Re: TMAC Responses to 2018 Nunavut Water Board Annual Report Comments

HOPE BAY PROJECT

Proponent's Response to Comments Received on the 2018 Annual Report

Figure 1. Comparison of Loading Sources to the TIA for Copper, Selenium, Sulfate and Nitrate

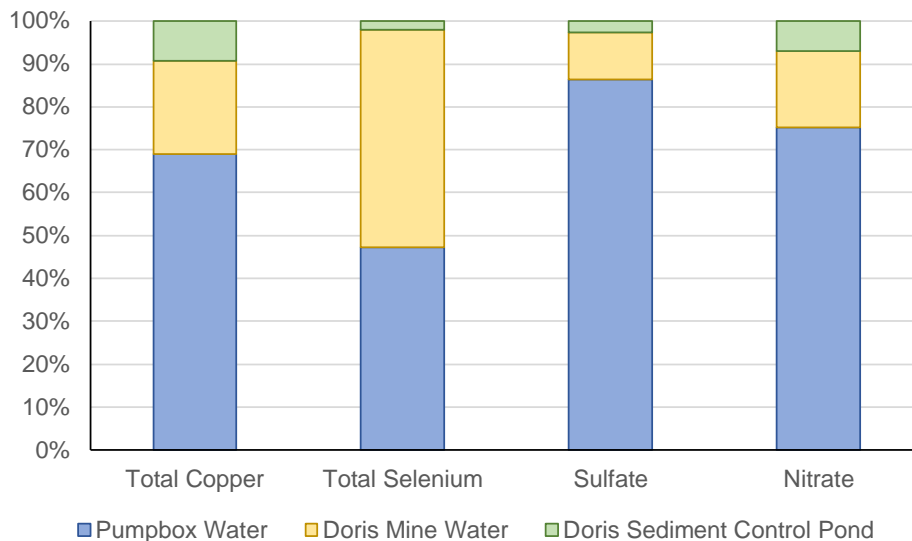
ECCC recommends the Proponent provide a discussion on the sources of ammonia in the process water and mine water and outline any current or planned measures being undertaken to reduce ammonia concentrations

The FEIS model included mine water and process water inputs based on the best available data at the time of preparation. It was expected that monitoring data collected during operations would differ to some extent from those initial inputs. Deviations in ammonia concentrations will be discussed separately for mine water and process water in the following paragraphs. Updated estimates for mine water and Doris TIA water, using adjusted source terms based on recently available measured data with higher ammonia concentrations, show that discharge will meet the MDMER limits for unionized ammonia. Regardless, TMAC will continue efforts to reduce ammonia concentrations.

Monthly loadings were calculated by multiplying the monthly flows by the average monthly chemistry. A summary of the annual loadings for total copper, total selenium, sulfate and nitrate are presented in Figure 1. Overall the Sediment Control Pond makes up to 10% of the 2018 annual loading to the TIA.
